**TOWN OF NEWBURGH
PLANNING BOARD
TECHNICAL REVIEW COMMENTS**

PROJECT: CBPS REALTY
PROJECT NO.: 18-20
PROJECT LOCATION: SECTION 35, BLOCK 1, LOT 21.2
REVIEW DATE: 14 NOVEMBER 2019
MEETING DATE: 21 NOVEMBER 2019
PROJECT REPRESENTATIVE: FUSCO ENGINEERING

CBPS Realty, LLC Self Storage
Section 35, Block 1, Lot 21.2
North Plank Road
Town of Newburgh
Orange County, NY
Our File #17-448

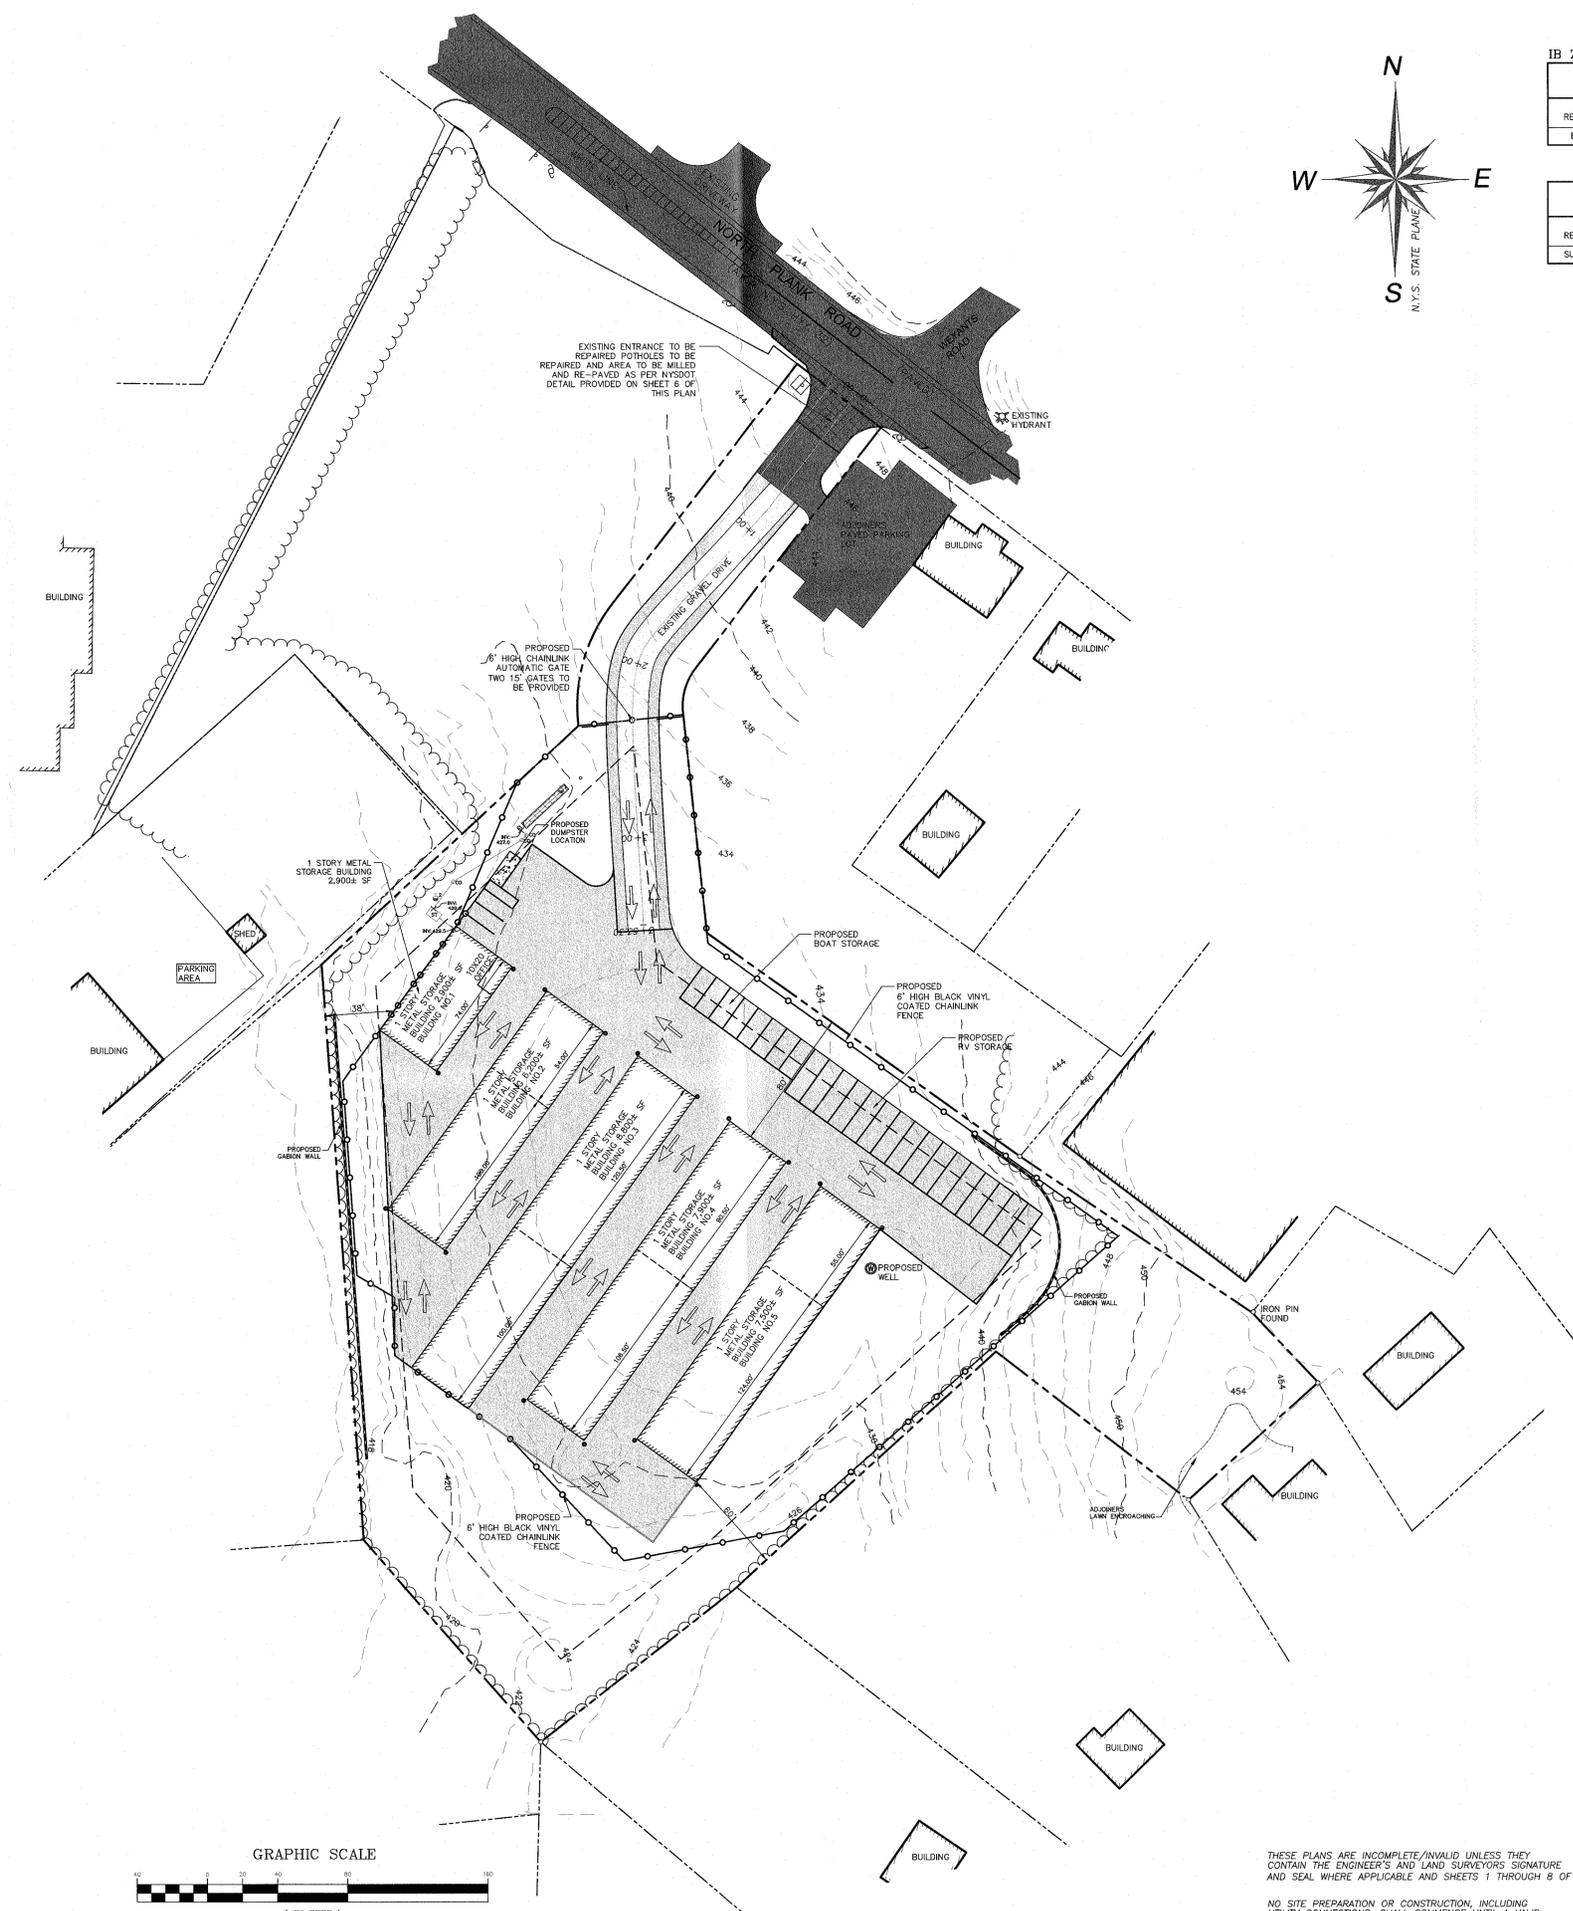
1. A well has been located on the plan sheet to provide water service for the site. The site is located in the Town's Consolidated Water District 1. Comments from Town Engineer, Jim Osborne, concerning the installation of a well within the water district to service a commercial property should be received.

3. The DOT details should be revised to reflect the repair overlay rather than the full section pavement identified.
4. The landscaping along the easterly portion of the site appears to conflict with proposed fencing. It is unclear if the landscaping is inside or outside the fence.

9. The proposed perimeter fence has been labeled as "black vinyl coated" chain link fence at the request of the board.
10. The sand has been specified as C-33 for the elgen detail as requested.

11. The SDS has been modified so that there is no significant fill in the area of the proposed SDS.
12. The fence now shows two 15' automatic gates opening in two directions to prevent it from opening onto adjoining lands.
